The National Construction Code Volume One

SSDA Submission

Nepean Hospital Redevelopment - Stage 2

Date: 30 September 2021

Figure No.02 – Typical locations of exposure of external walls of different fire compartments throughout the building

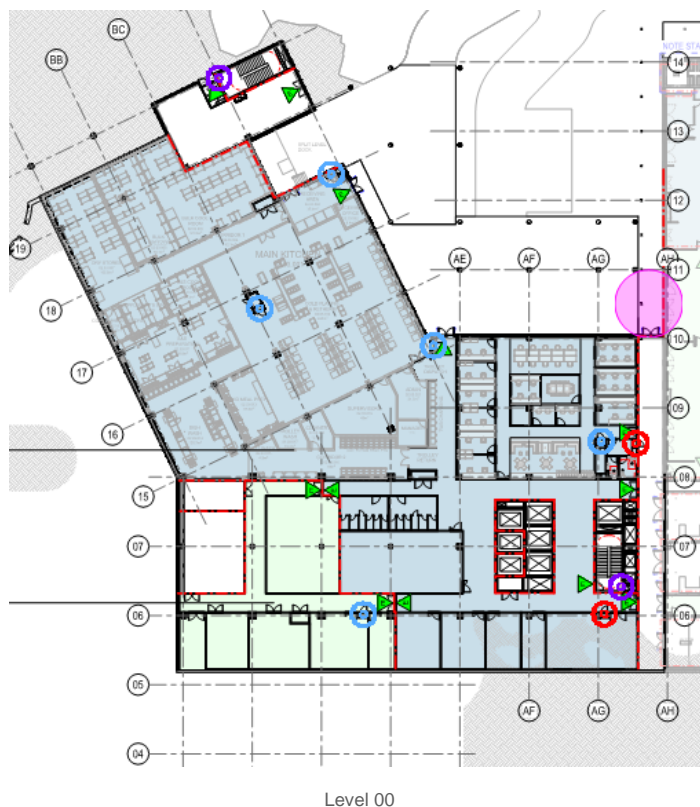
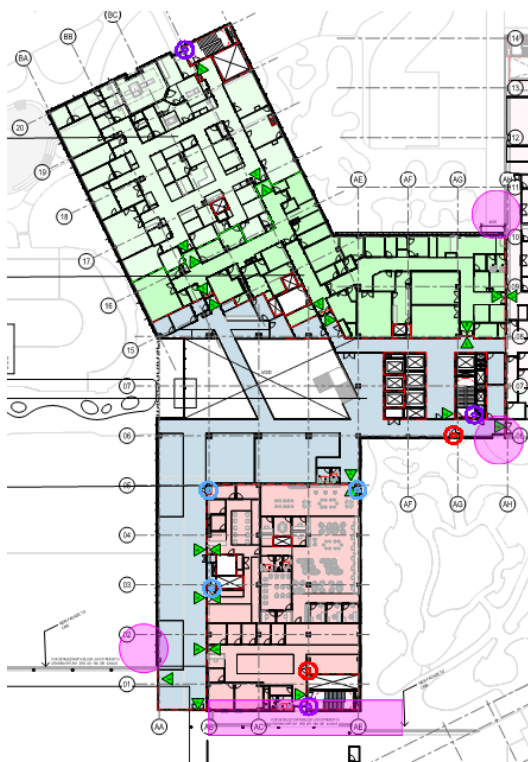
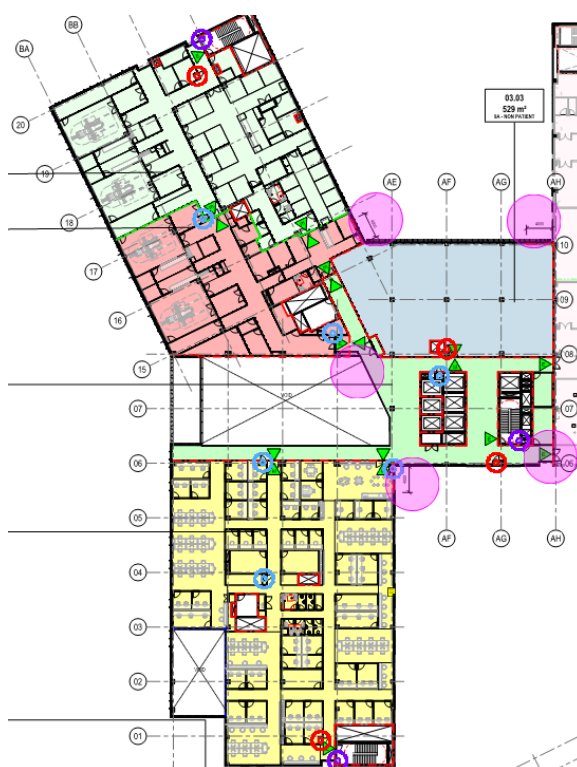
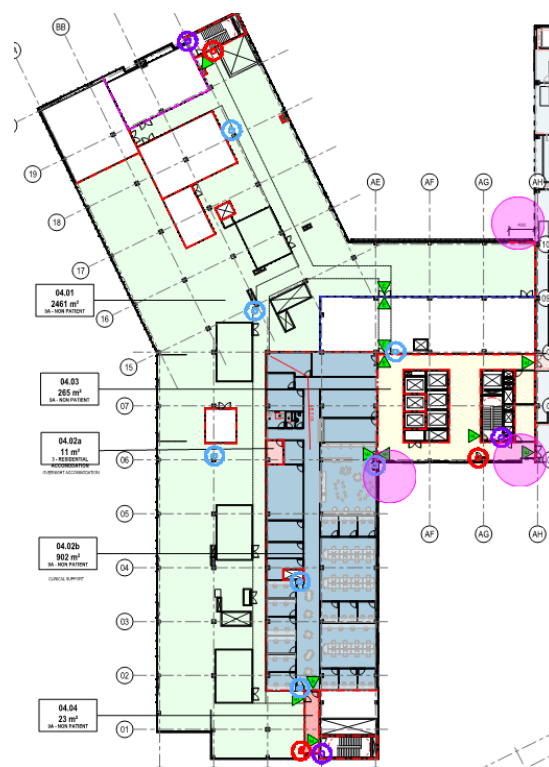
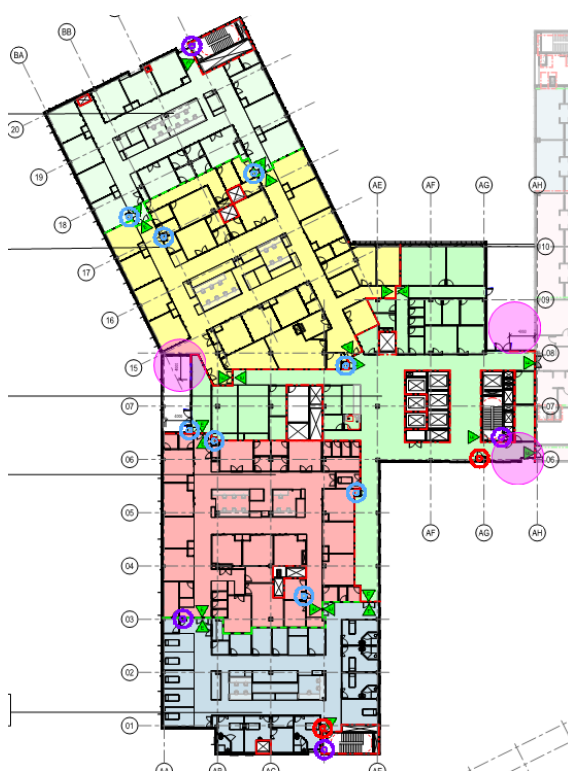
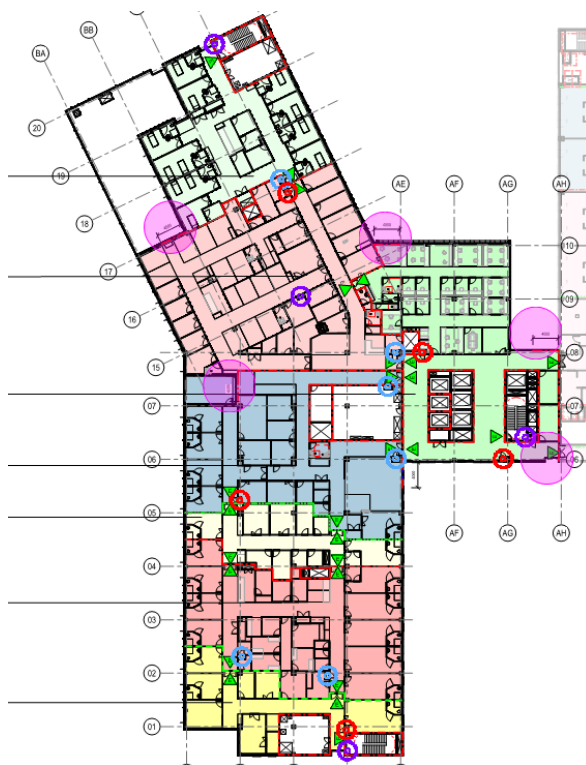
There are numerous locations throughout the building where exposure occurs between external walls and their associated openings of different fire compartments. The below figure details an example of locations throughout the building where exposure occurs at the junction of external walls of different fire compartments.

The subject external walls and openings will be assessed as part of a Fire Engineering Performance Assessment to be undertaken by Arup in order to demonstrate compliance with the nominated Performance Requirements of the BCA.

Figure No. 03 – Required fire separation of Stage 2 Tower from existing adjoining buildings on Level 02

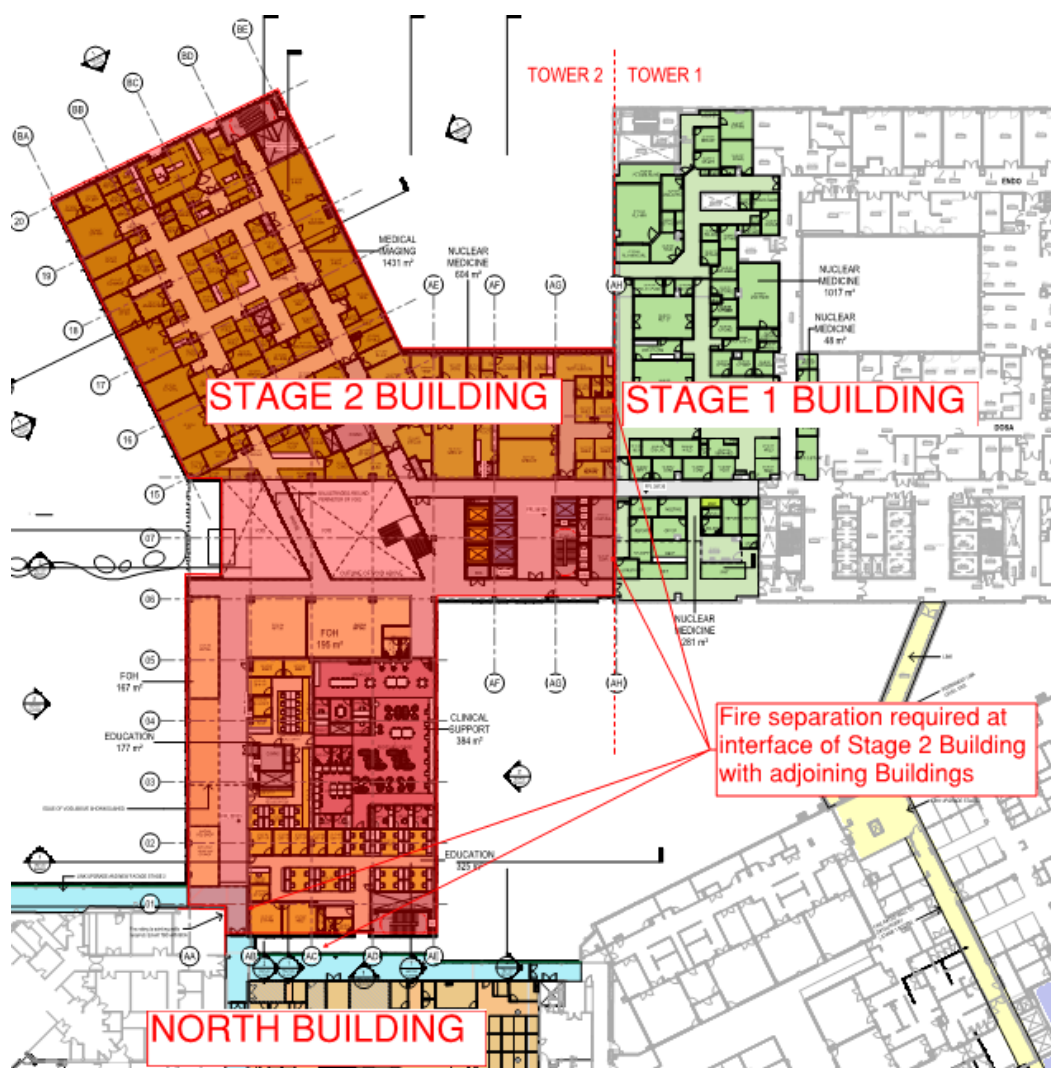
All new linkways, enclosed corridors etc will be assessed as part of the Stage 2 Tower and will be required to be adequately fire and smoke separated from the existing hospital buildings.

Figure No. 04 – Location of Class 3 overnight room on Levels 04

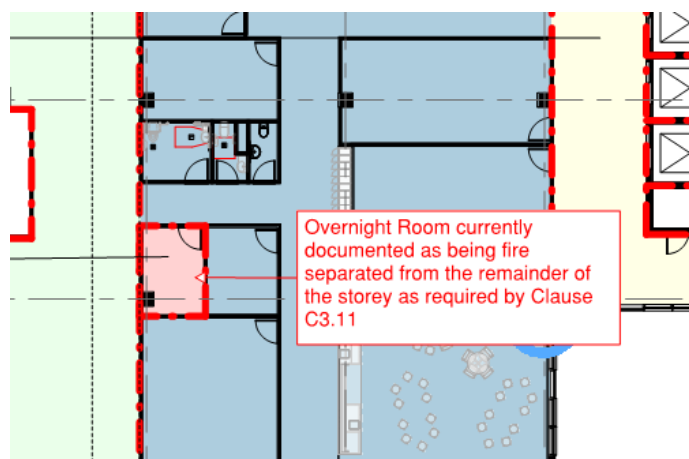
The overnight room located on Level 04 provided for staff is classified as Class 3 in accordance with Part A6 of the BCA.

In accordance with Clause C3.11 and Specification C1.1, the overnight room is deemed a sole occupancy unit and is required to be fire separated from the remainder of the building based on the classification of Class 3 residential accommodation.

Figure No. 05– Fire safety doors that swing against the direction of egress on Levels 02, 05 & 06

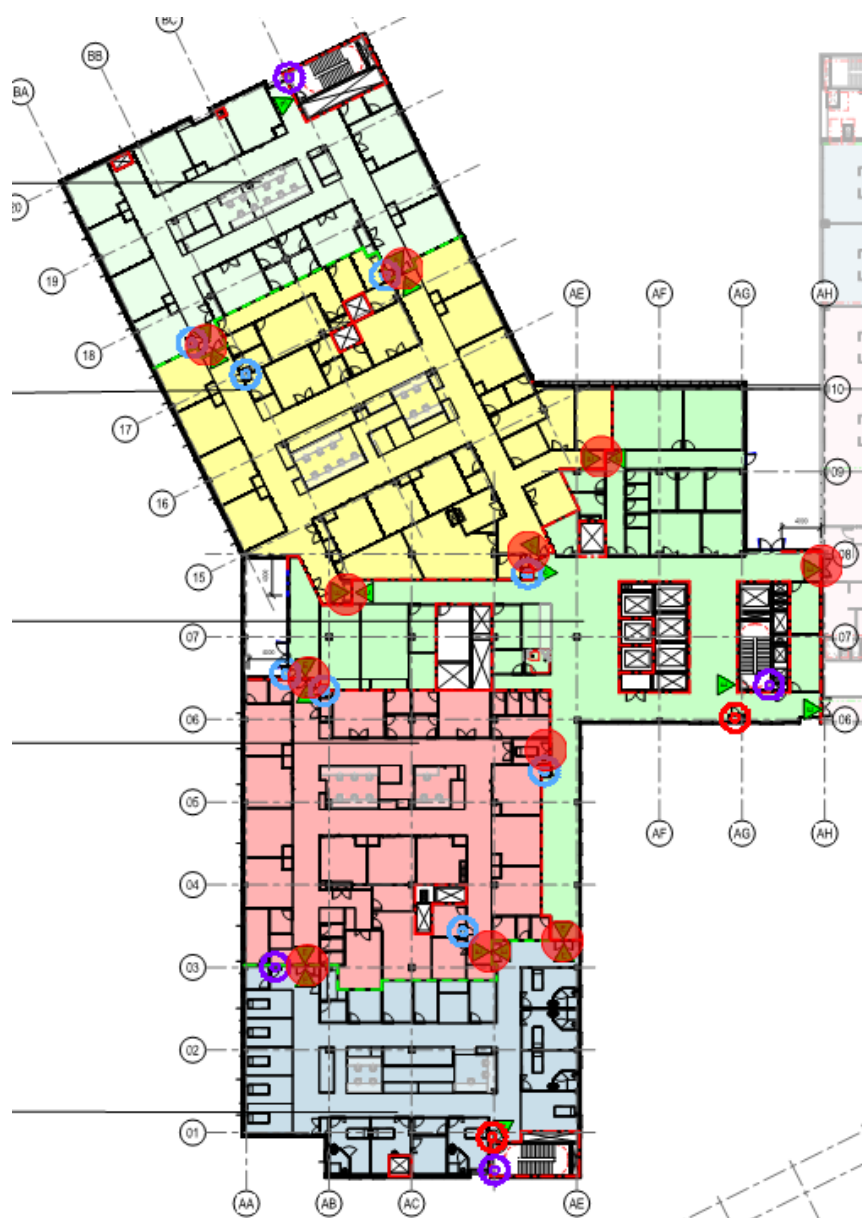
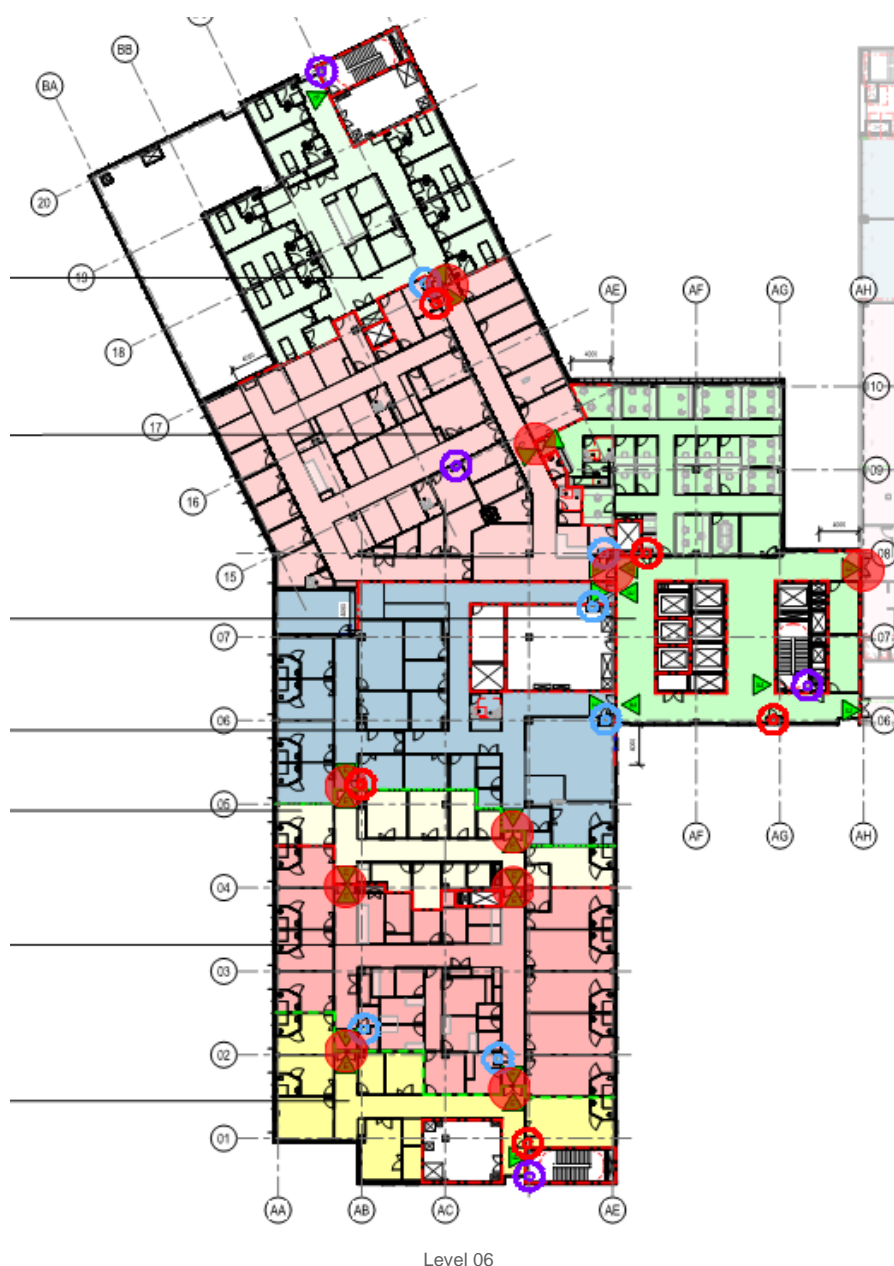
The proposed swing of the doors in one direction only or against the direction of egress will be required to be assessed as part of the Fire Engineering Assessment to be undertaken by Arup in order to demonstrate compliance with the nominated Performance Requirements of the BCA.

Figure No. 06 – Fire Stair 01 discharging into the confines of the building on Level 01

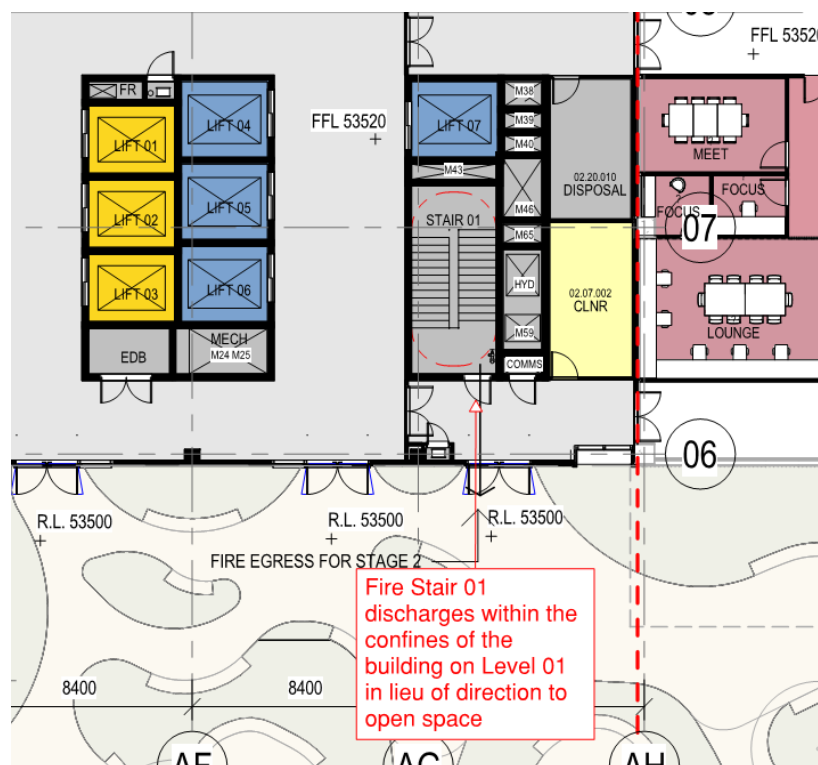
Fire Stair 01 discharges within the confines of the building on Level 01 to the lobby space in lieu of the stairway discharging directly to open space as required by Clause D1.7.

Consistent with the Performance Solution for the two Fire Stairs in the Stage 1 Hospital, the discharge of the fire isolated stairway will be required to be assessed as part of the Fire Engineering Assessment to be undertaken by Arup in order to demonstrate compliance with the nominated Performance Requirements of the BCA.

Figure No. 07 – External pathways to be located a minimum distance of 6m from the external wall of the building

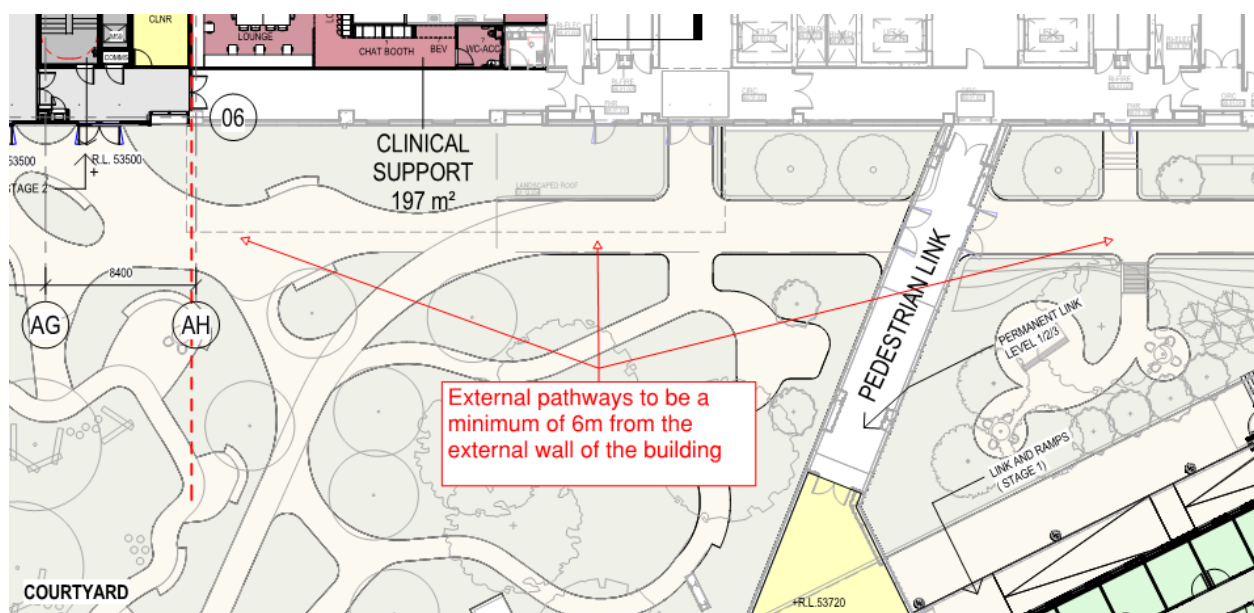
Once occupants discharge from the fire isolated stairway on the Southern Elevation, the external pathway they travel on is required to be located a minimum distance of 6m from the external wall of the Stage 1 and 2 Tower. If the path of travel is less than 6m from the external wall, the external wall and any openings located within it are required to be protected.

Figure No. 08 – Discharge of Fire Stairs 01 & 03 on Level 01 via the internal courtyard

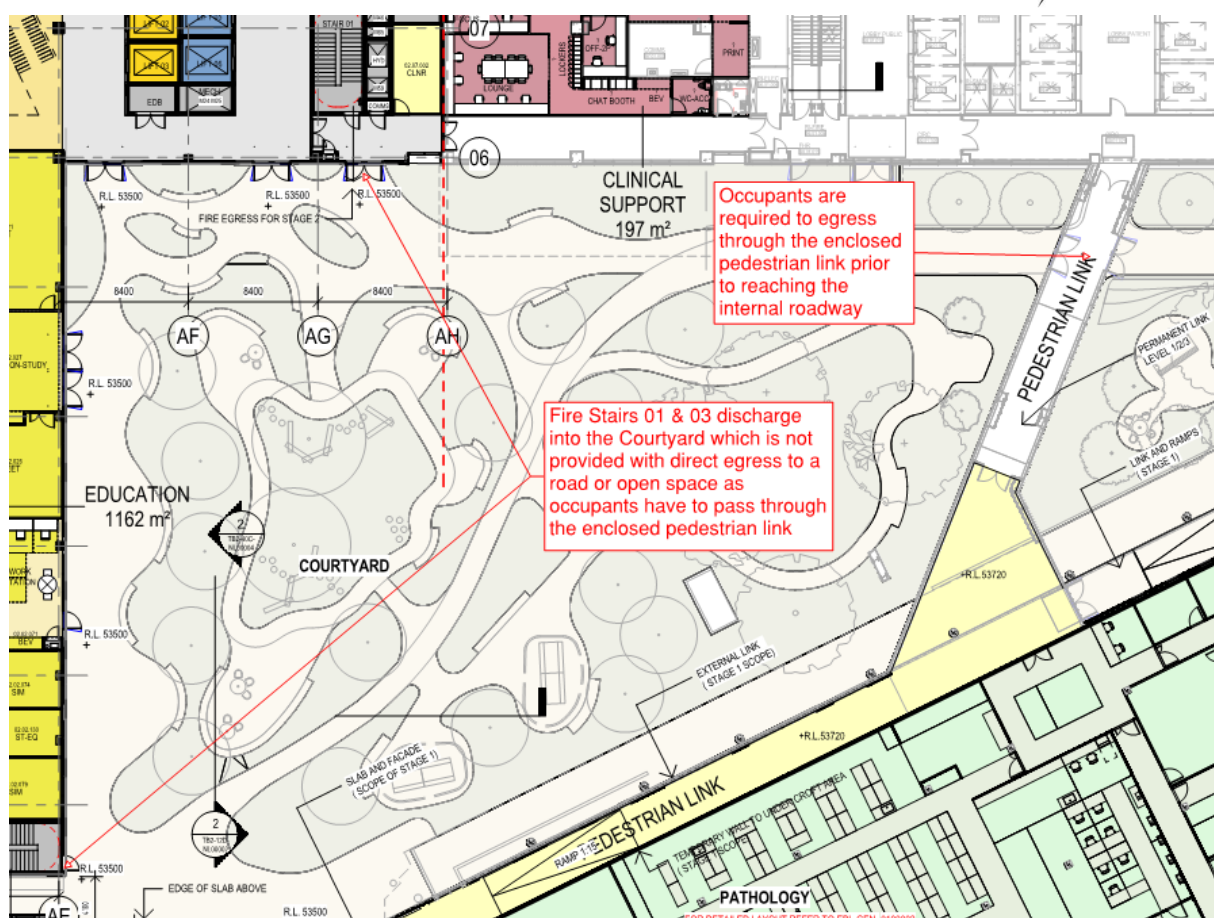
Occupants having to pass back within the confines of the linkway is a non-compliance and will be required to be assessed as part of the Fire Engineering Assessment to be undertaken by Arup in order to demonstrate compliance with the nominated Performance Requirements of the BCA.

Note: The Performance Solution will also be required to address any required exits discharging from the Education space along with the FOH that discharge into the courtyard area.

Figure No. 09 – Bollards to be installed in front of exit doors discharging on Level 00

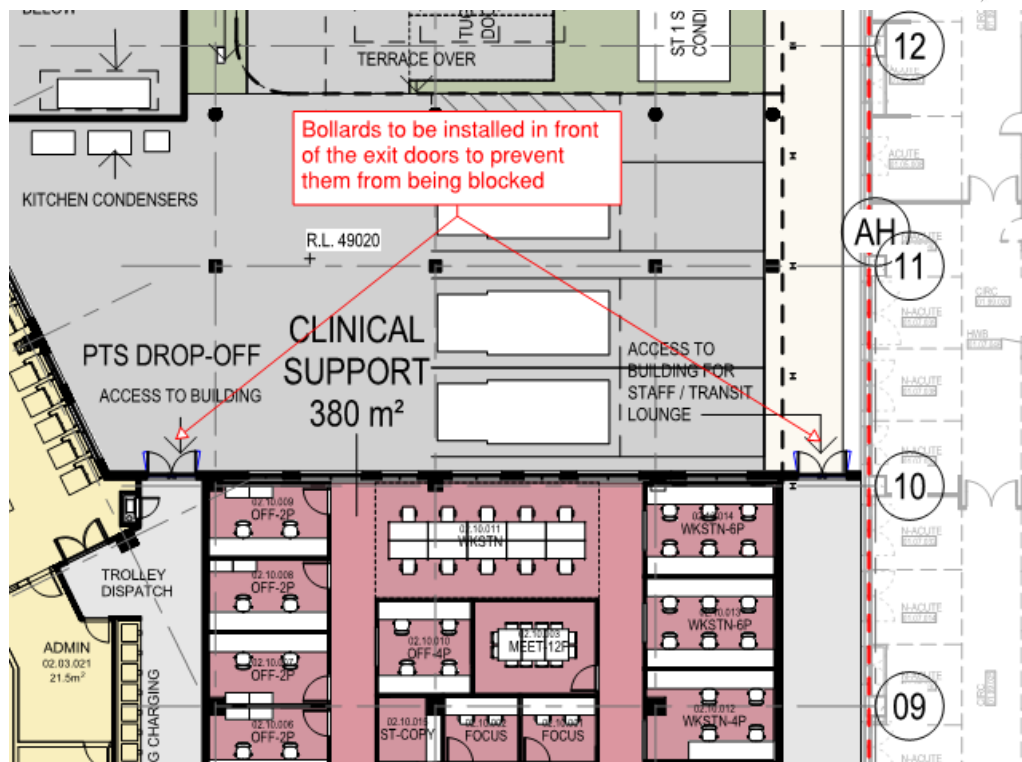
An exit cannot be blocked at the point of discharge and where necessary suitable barriers are to be installed to prevent vehicles blocking the exit i.e., installation of bollards.

Figure No. 10 – Non required non-fire isolated stairway within the Kids Atrium connecting Levels 02 & 03

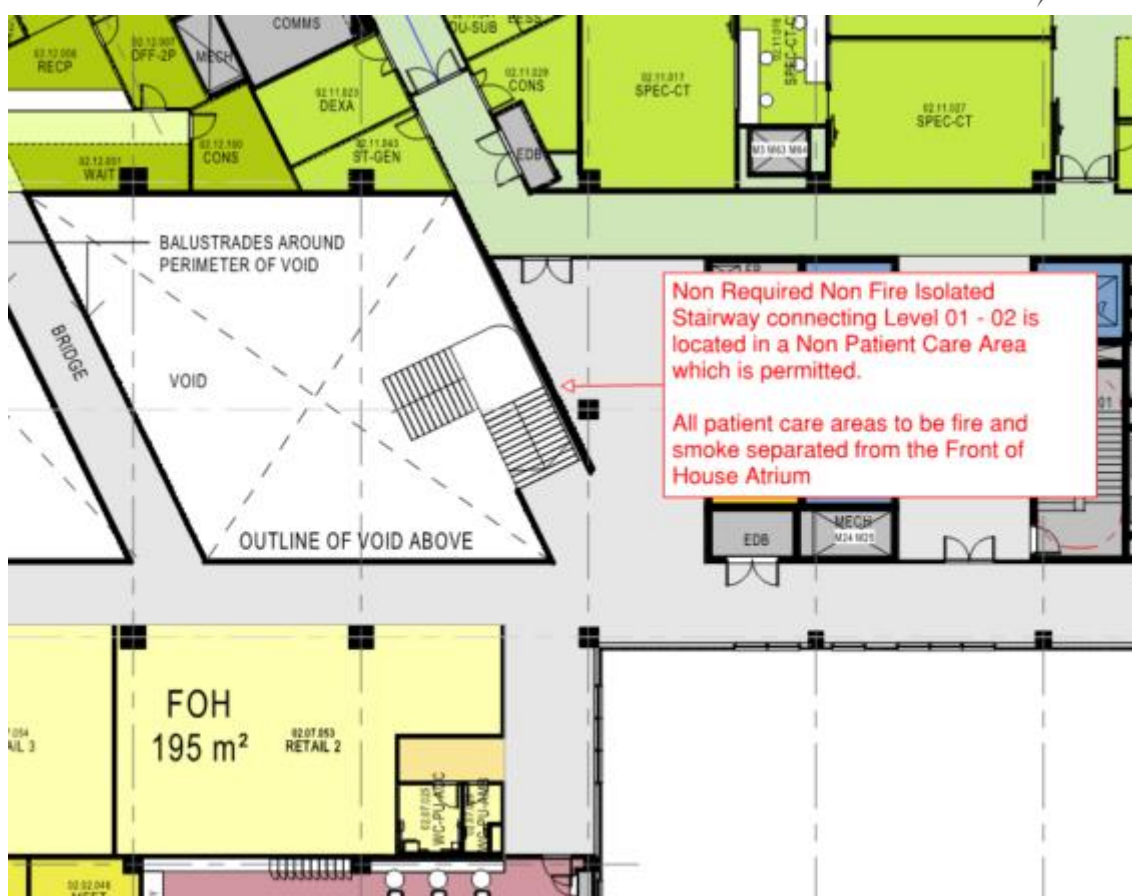
No patient care areas can be directly connected to or open onto the front of house area without being fire and smoke separated.

The discharge of horizontal exits into the front of house area occupied by the non-required non-fire isolated stairway and void will be required to be assessed as part of the Fire Engineering Strategy developed for the building.
